2nd Addendum Committee Report

| Development Management Report | |
|---|--|
| Application ID: LA04/2021/2285/F | Date of Committee: 16 th August 2022 |
| Proposal: Proposed 2.5 storey residential apartment building comprising 11 No. apartments (social), amenity space, landscaping, access, parking and ancillary site works (Amended Plans) | Location: 29 Parkside Gardens, Belfast, Co. Antrim, BT15 SAW |

A Proposed Eastern Elevation
Scale 1:100

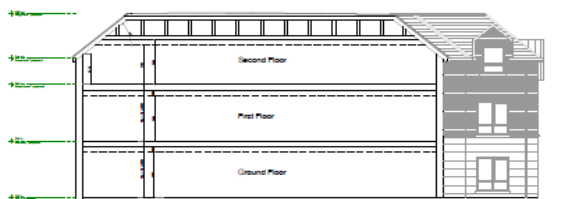
The outlook for south facing apartments has been altered with the addition of obscured glazing to habitable rooms (kitchens). As these windows are located in habitable rooms (kitchen/dining area) it would be unreasonable to use obscure glazing and would impact the quality of the living environment. The use of obscure glazing to habitable rooms is an indication of over development.
